PLANNING REVIEW CHECKLIST

Second Review Comments

Subject Property: 5730 Lone Oak Road SE

Reference Nos.: 21-122528-LD (UGA Preliminary Declaration)
21-122530-LD (Subdivision)
21-122532-ZO (Class 2 Zoning Adjustment)
21-122538 (Tree Conservation Plan)

LOT LAYOUT PLAN

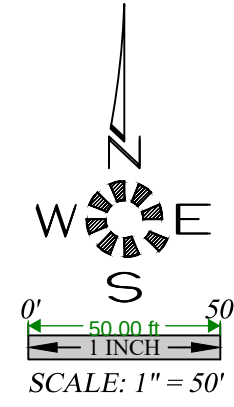
Min. 120-foot double frontage lot depth not meet. **Class 1 Adjustment** required to minimum double frontage lot depth.

Exceeds max. lot depth.
Class 1 Adjustment needed to maximum lot depth.

Exceeds max. lot depth.
Class 2 Adjustment needed to maximum lot depth.

Alternative Street Standard required for Red Oak Avenue

Alternative sidewalk location approval required per SRC 803.035(1)(2)(B) to allow sidewalk abutting curb.

The proposed street layout requires right-of-way to be obtained from the abutting property owner to the south for the construction of Sarah Renee Avenue. Property owner to the south is required to sign the application form since a portion of the subdivision will be their property. A property line adjustment will also be required prior to final plat approval to incorporate this portion of the property into the subdivision.

Property proposed to be rezoned to MU-II (Mixed-Use) under the Our Salem project. A future street connection bisecting the majority of the property would not be feasible for development of the mix of uses envisioned under the proposed MU-II zoning.

A future street connection to Lone Oak Road appears to be possible that doesn't split the entire property. Staff is available for further conversation and/or meetings to discuss potential feasible alternatives.

TREE CONSERVATION
N.W. QUADRANT

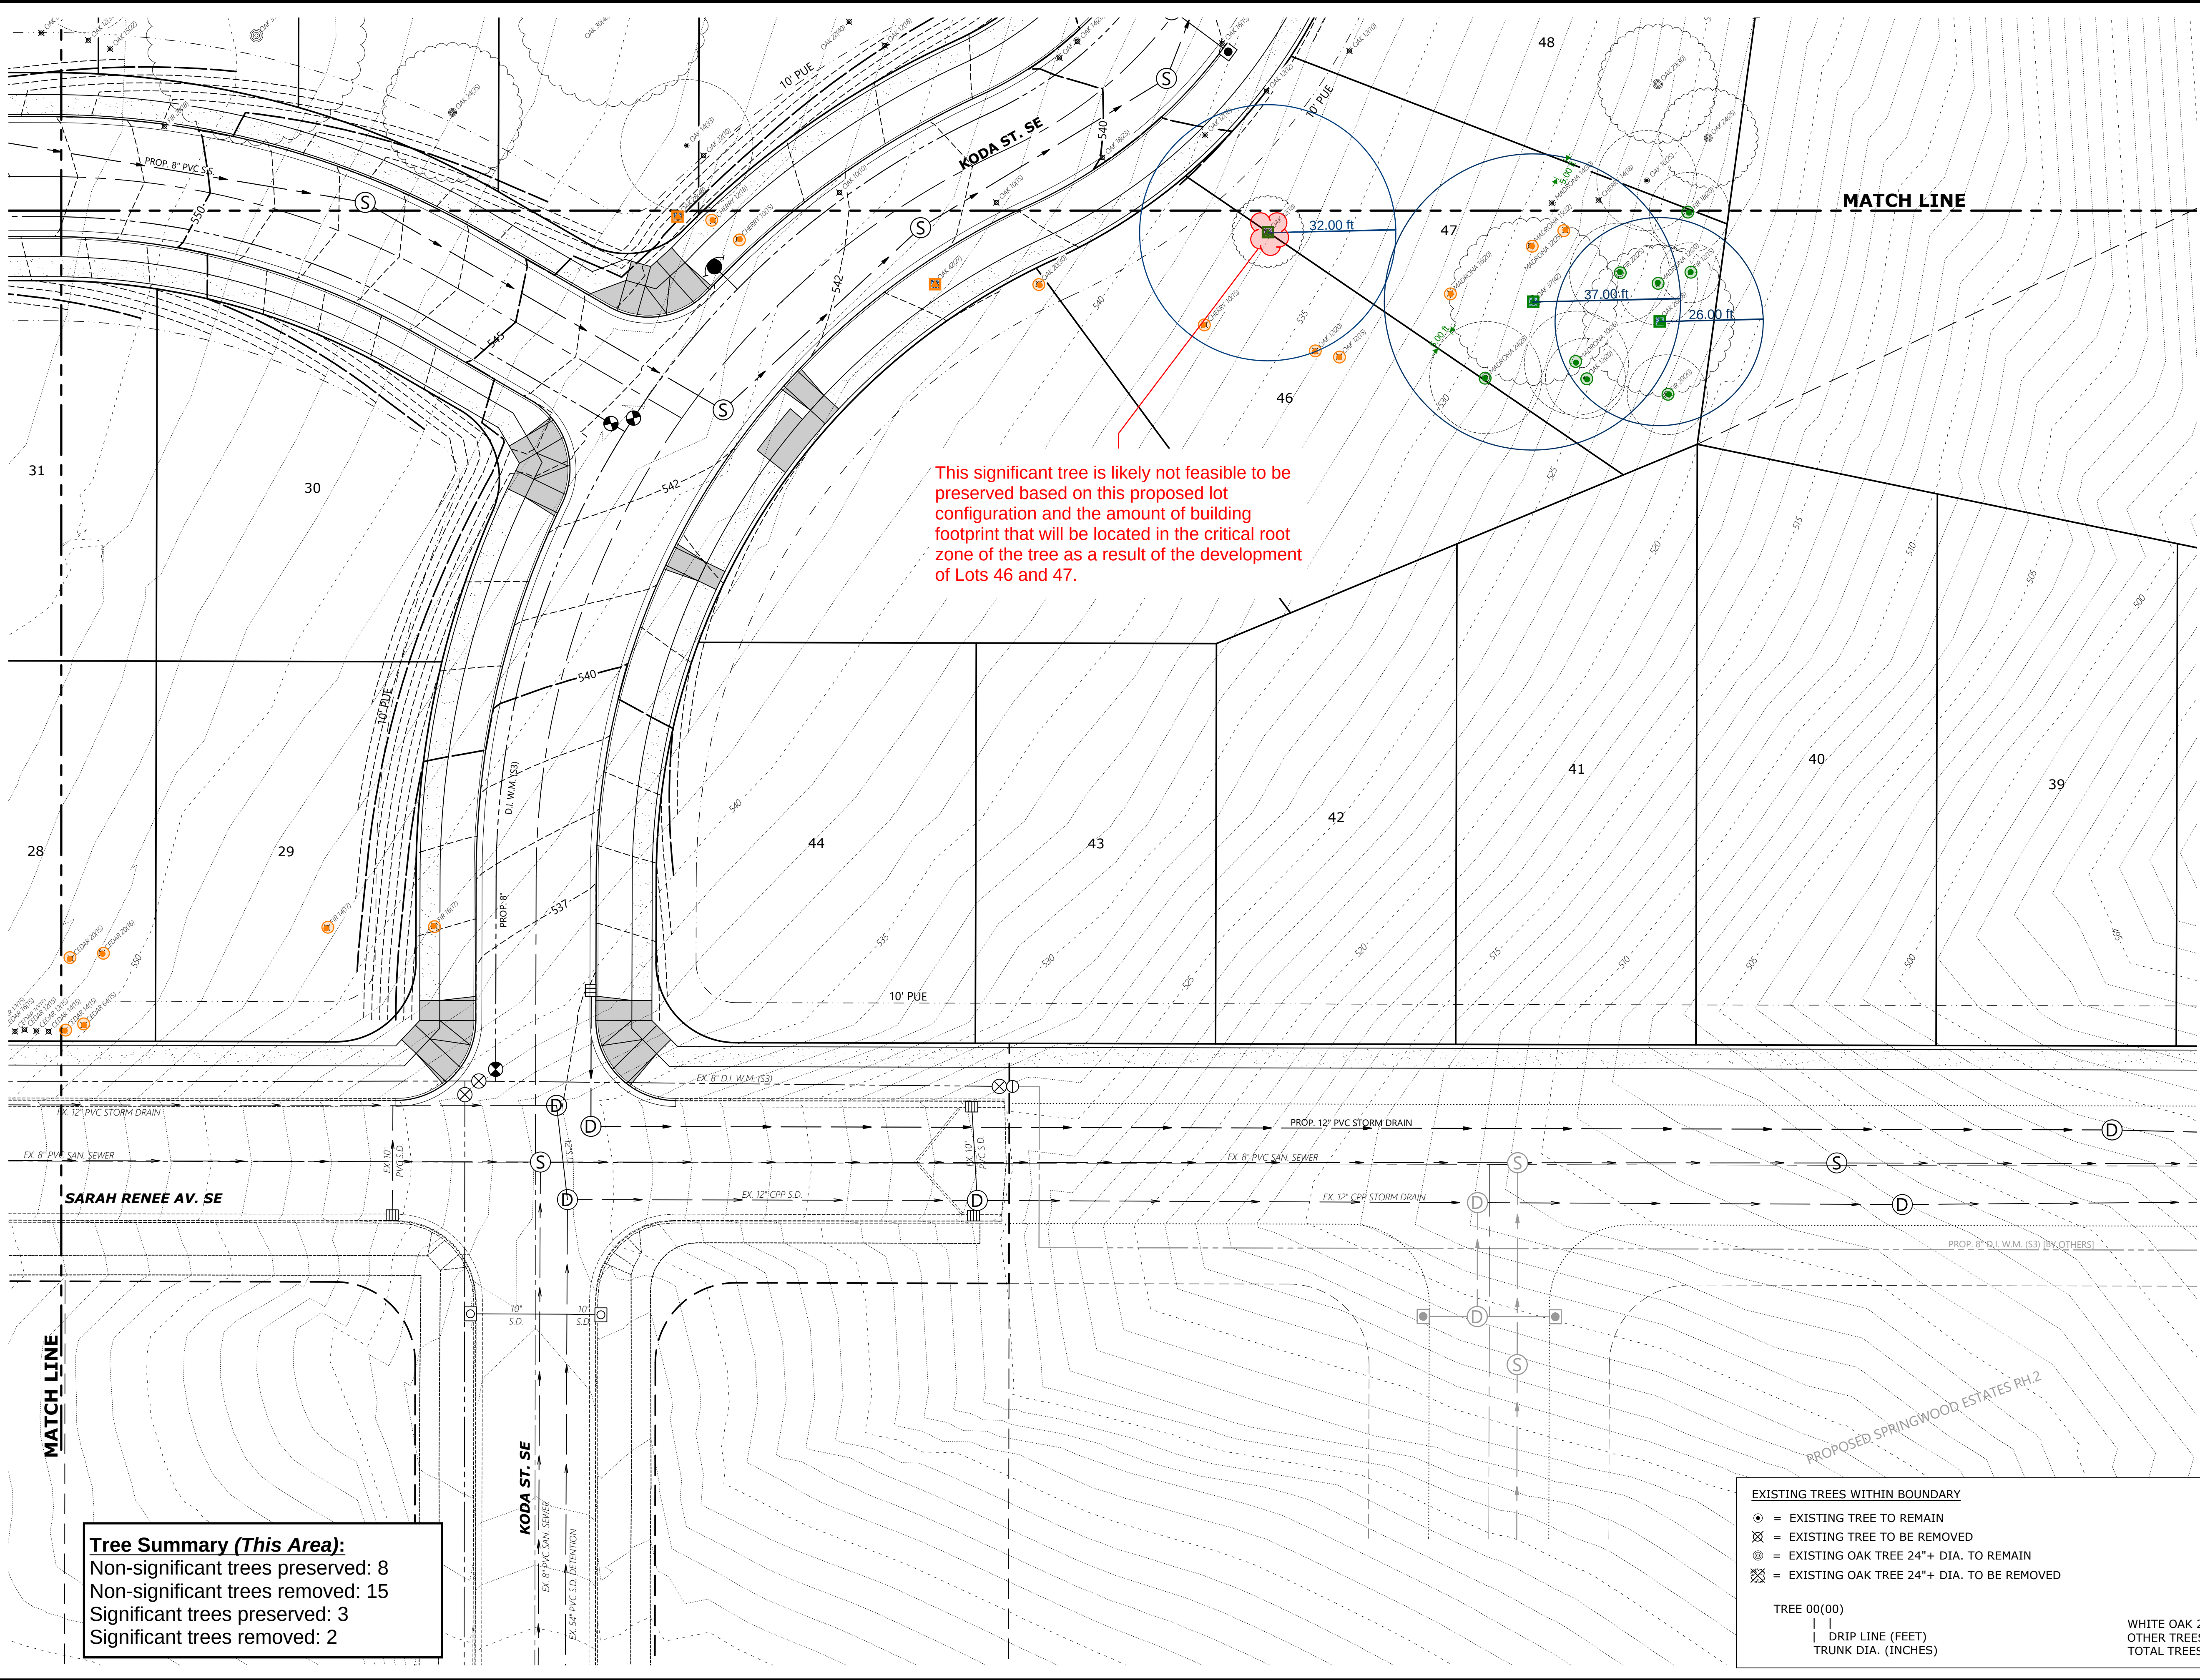
SRC 808.035 (under the old SRC 808 standards prior to the 2021 UDC update) requires a minimum of 70 percent of the critical root zone of significant trees to be protected by an above ground silt fence.

Based on the amount of grading that will be required in the critical root zone of this tree it appears that it will exceed the max. allowed 30 percent and this tree will not be able to be designated for preservation.

My count shows 107 non-significant trees for preservation. Three tree difference.

My count shows 450 total trees on site. Three tree difference.

This significant tree will be in the middle of the building envelope of the lot and is likely not feasible to be preserved based on this proposed lot configuration.

This significant tree is likely not feasible to be preserved based on this proposed lot configuration.

All of these trees are in the middle of the building envelopes of these lots and don't appear to be able to be preserved based on this proposed lot configuration.

This grouping of trees will need to be preserved. Is it possible to reconfigure the lots in this area so that future building envelopes will be outside of the critical root zones of the significant oaks?

The lots are deep. Is it planned that homes would be constructed in the rear portions of the lots outside of the critical root zones? Are all of these trees sound and healthy or are some unhealthy and compromised by the ice storm?

An explanation is needed demonstrating how these trees that are designated for preservation will be able to be preserved with the development of the lots or a reconfiguration of the lots will be needed.

TREE CONSERVATION N.E. QUADRANT

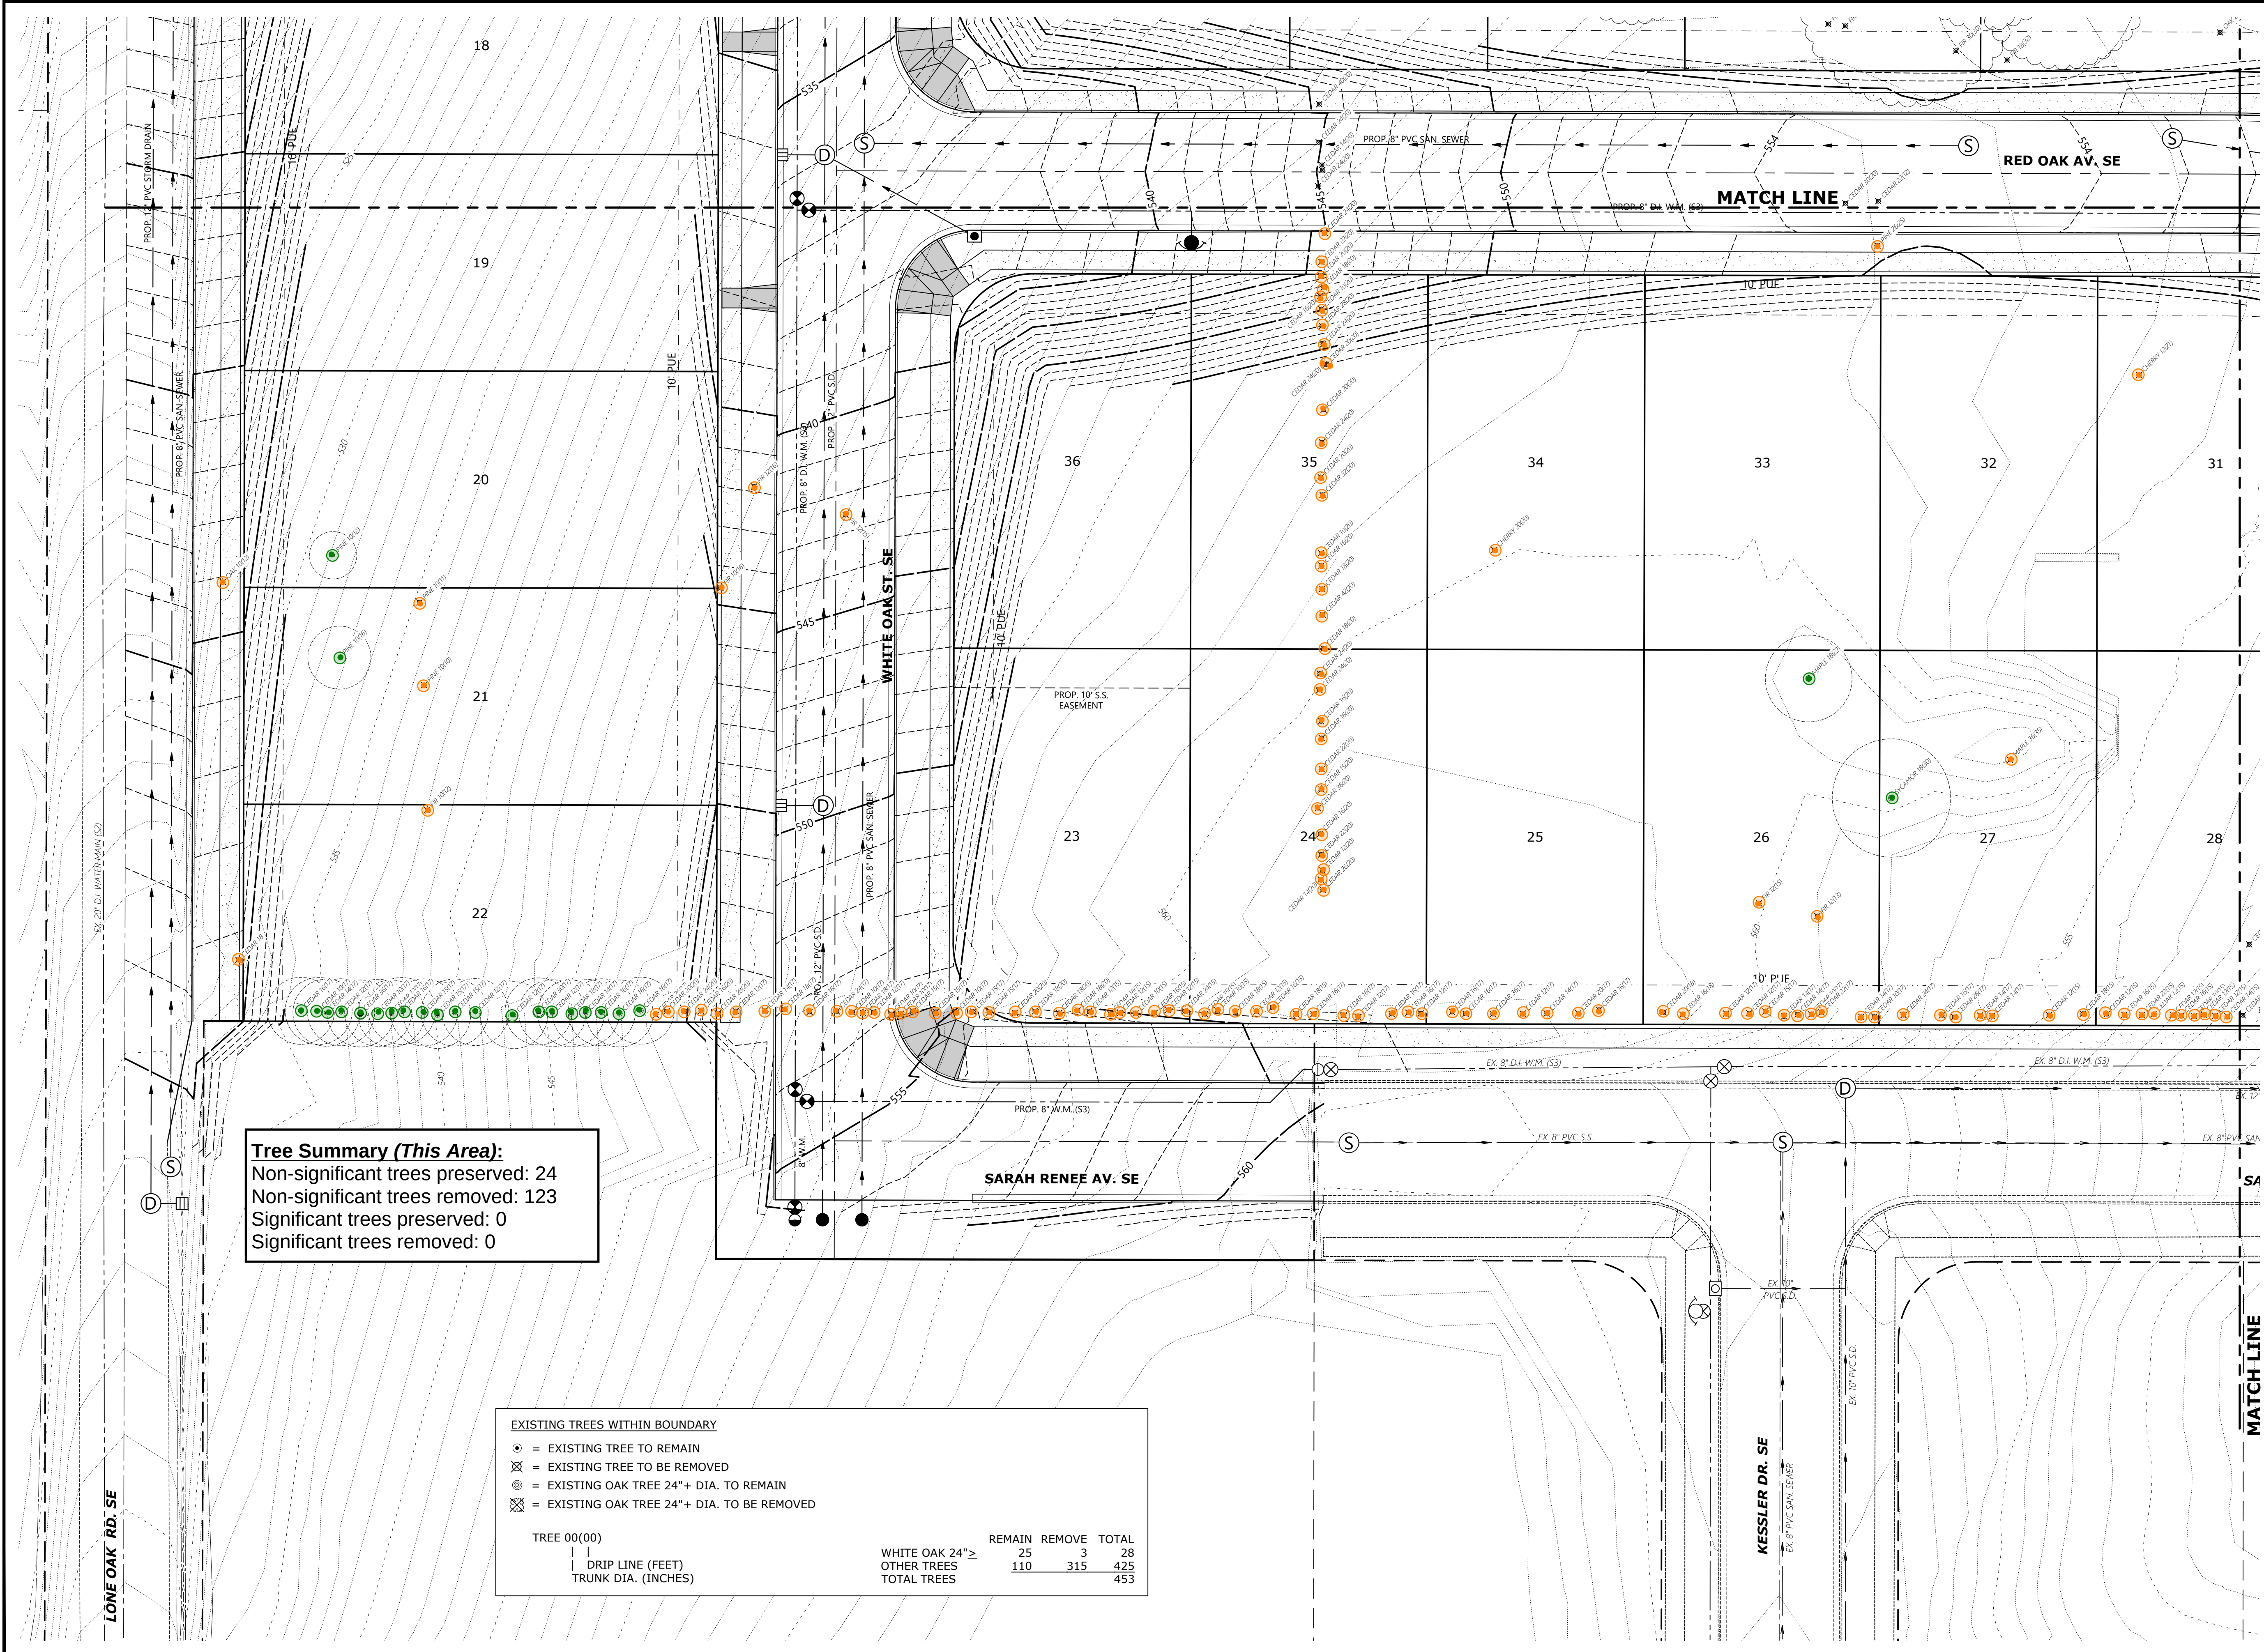
All of these trees are in the front of the building envelopes of these lots and don't appear to be able to be preserved based on this proposed lot configuration.

This grouping of trees will need to be preserved. Is it possible to reconfigure the lots in this area so that future building envelopes will be outside of the critical root zones of the significant oaks?

The lots are deep. Is it planned that homes would be constructed in the rear portions of the lots outside of the critical root zones? Are all of these trees sound and healthy or are some unhealthy and compromised by the ice storm?

An explanation is needed demonstrating how these trees that are designated for preservation will be able to be preserved with the development of the lots or a reconfiguration of the lots will be needed.
